This sheet transmits Revision 1 to MTB-33-03, which:

LIGHTS - LED TAIL STROBE LIGHT INSTALLATION

MTB-33-03  
Page 1 of 15

Figure 1. Before Modification (Sheet 1)

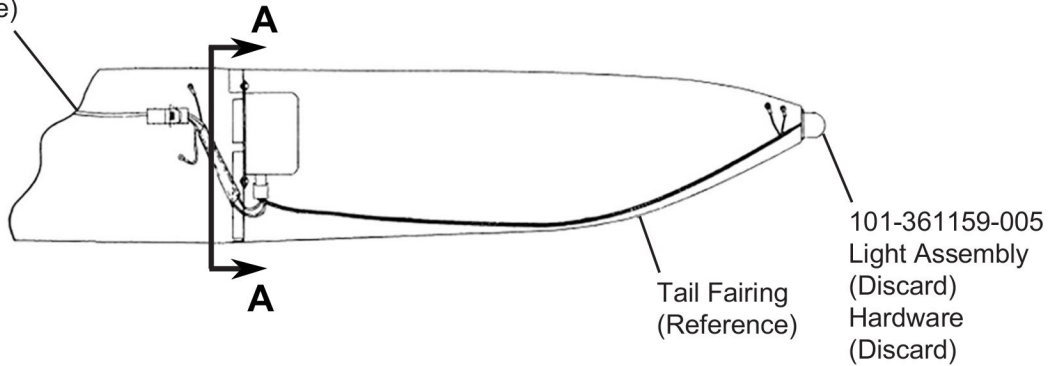
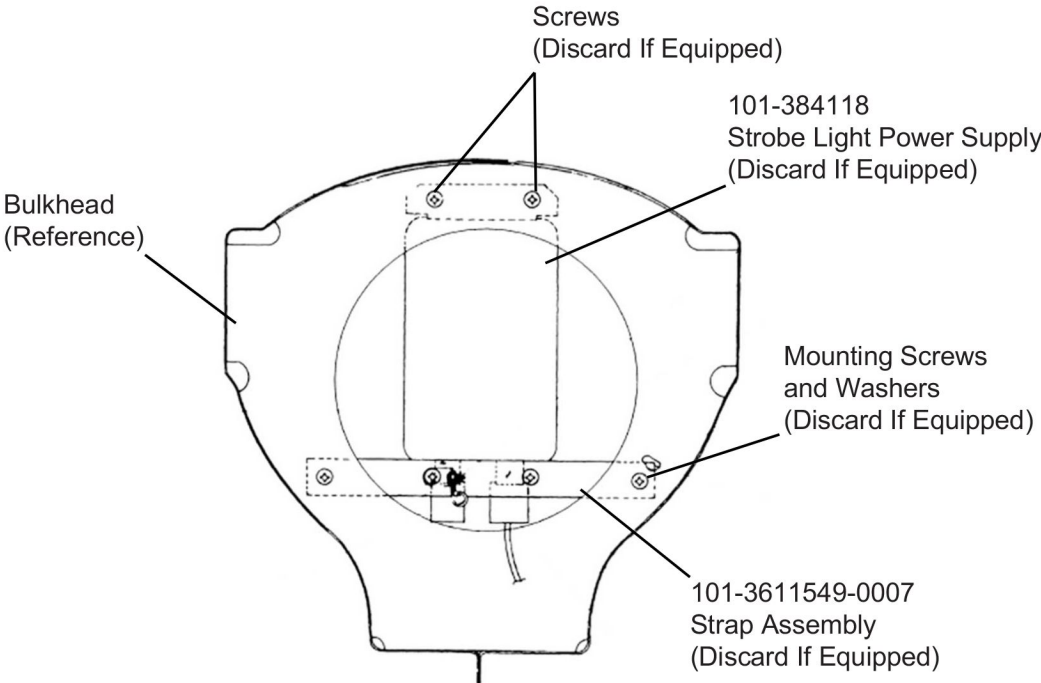
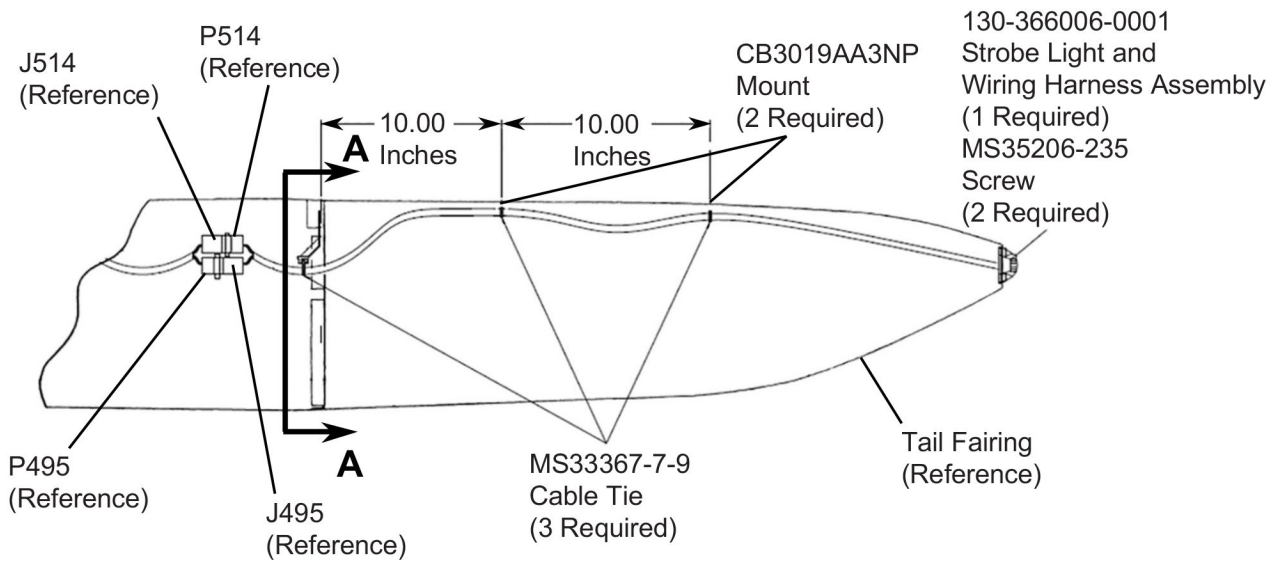
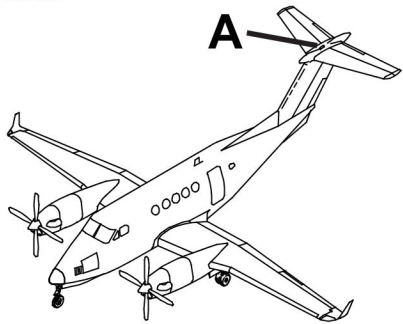
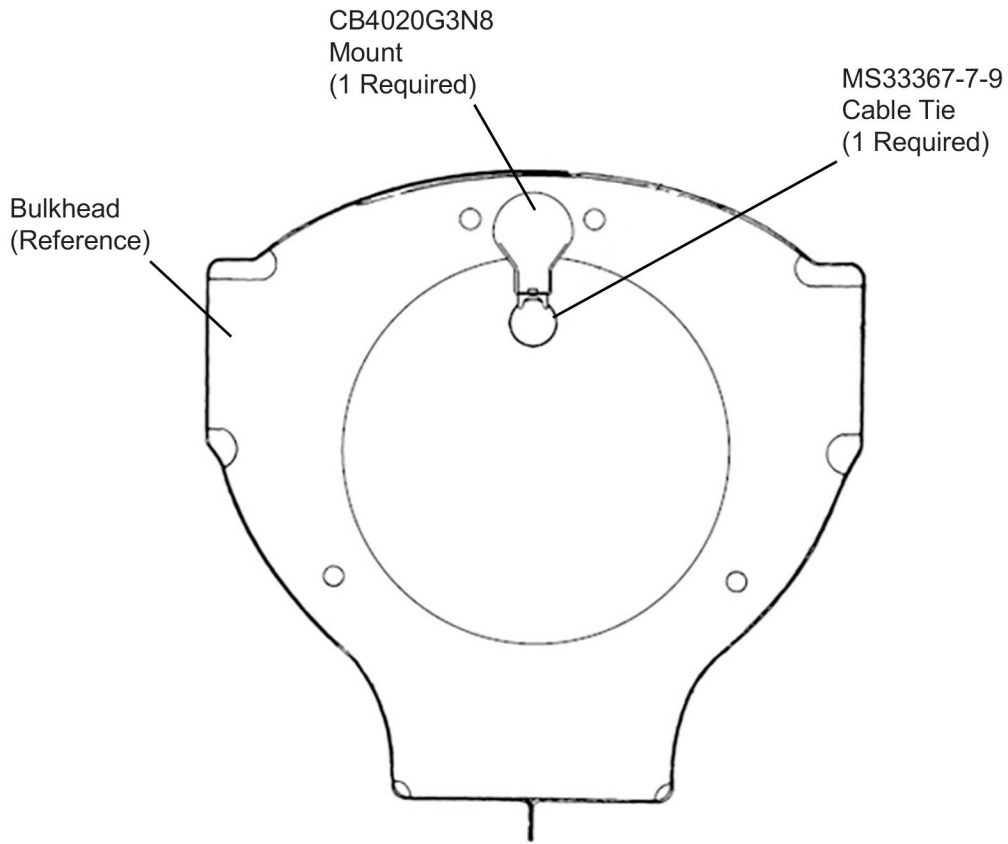
3. (Refer to Figure 1, Sheets 1 and 2.) Remove the aft tail strobe light assembly and wiring as follows:

- A. Airplanes equipped with a 101-384118 Strobe Light Power Supply, go to Step 3 C.  
B. Airplanes not equipped with a 101-384118 Strobe Light Power Supply, go to Step 3 F.  
C. Remove and discard the four screws that attach the 101-384118 Strobe Light Power Supply.  
D. Remove and discard the two mounting screws and washers that attach 101-3611549-0007 Strap Assembly to the bulkhead.  
E. Discard the 101-3611549-0007 Strap Assembly.  
F. Remove and discard the hardware that attaches the 101-361159-005 Light Assembly to the tail fairing.  
G. Discard the 101-361159-005 Light Assembly and the associated harness.

5. (Refer to Figure 3, Sheets 1 and 2.) Install the 130-366006-0001 Strobe Light and Wiring Harness Assembly as follows:

- A. Apply EA9309 Adhesive to the two CB3019AA3NP Mounts.  
B. Install the two CB3019AA3NP Mounts onto the upper surface of the tail fairing approximately 10.0 inches from the bulkhead and from each other.  
C. Apply EA9309 Adhesive to the CB4020G3N8 Mount and install the CB4020G3N8 Mount to the forward side of the bulkhead in the tail fairing.  
(1) Make sure the EA9309 Adhesive has had time to cure.  
D. Install the wiring harness of the 130-366006-0001 Strobe Light and Wiring Harness Assembly from the aft end of the tail fairing.  
E. Electrically bond the 130-366006-0001 Strobe Light and Wiring Harness Assembly to the aft end of the tail fairing.  
(1) Apply adequate U470638 Sealant between the 130-366006-0001 Strobe Light and Wiring Harness Assembly and tail fairing.

Figure 2. Wiring Modifications (Sheet 1)

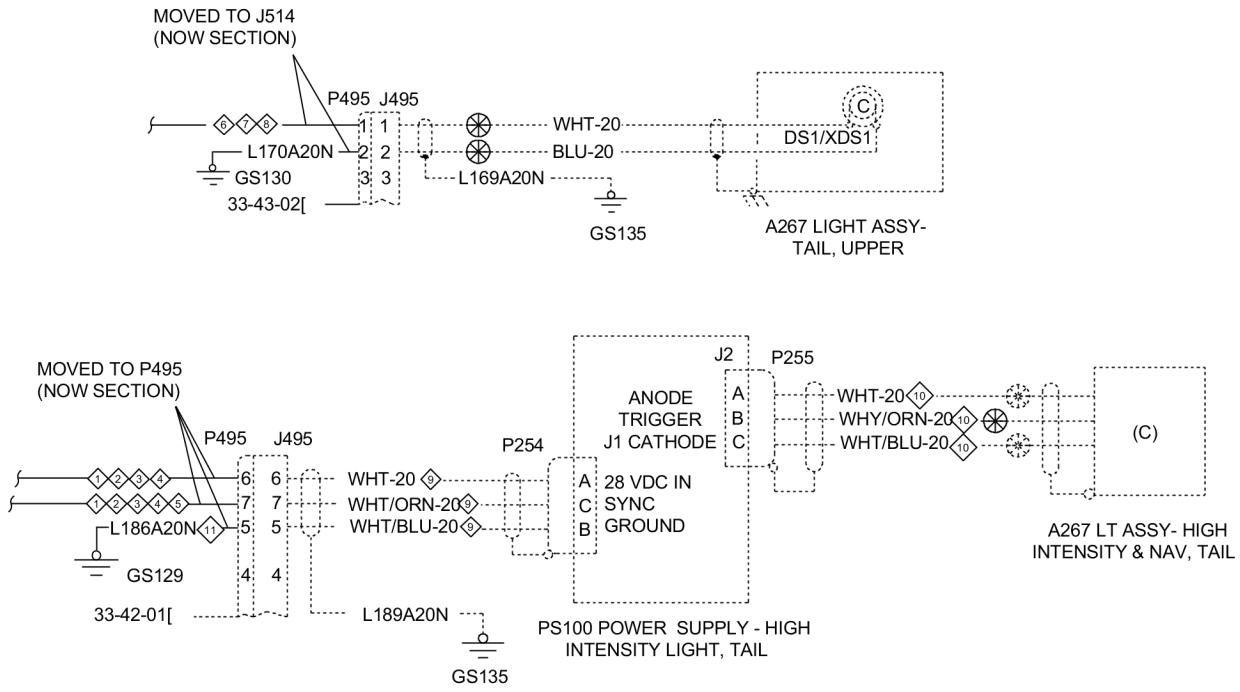
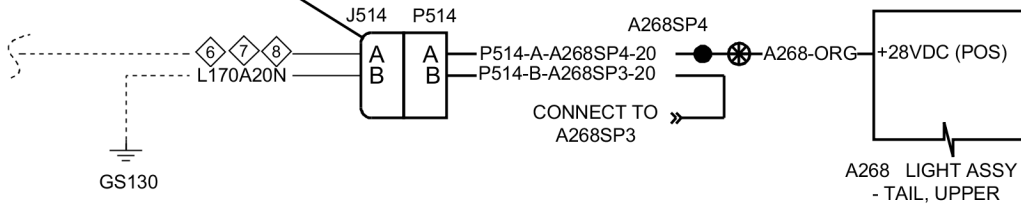
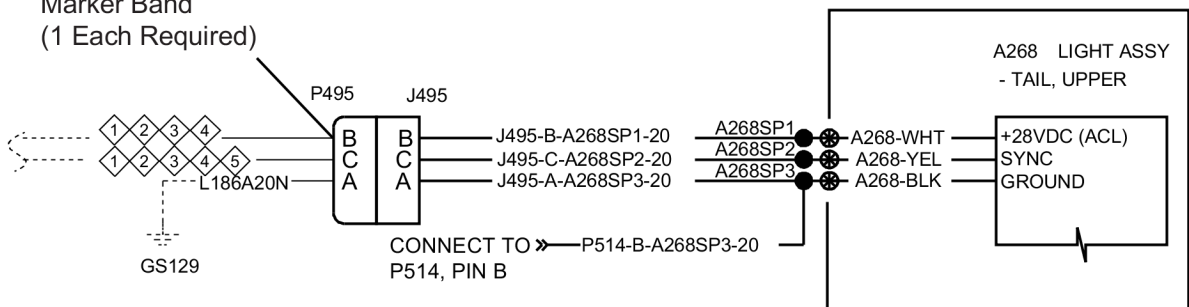
4. (Refer to Figure 2, Sheets 1, 2, and 3.) Do the wiring modification to the airplane wiring harness as follows:

- A. Remove and discard the P495 Connector.  
B. Install a SJS840400 Pin Receptacle two M39029/58-364 Contact Pins and two MS27488-16 Sealing Plugs onto the existing airplane wiring harness.  
C. Install a SJS840410 Pin Plug with three M39029/57-358 Sockets and one MS27488-16 Sealing Plug onto the existing airplane wiring harness.  
D. Install and label each connector using one 131741-3 Marker Band onto the airplane wiring harness.
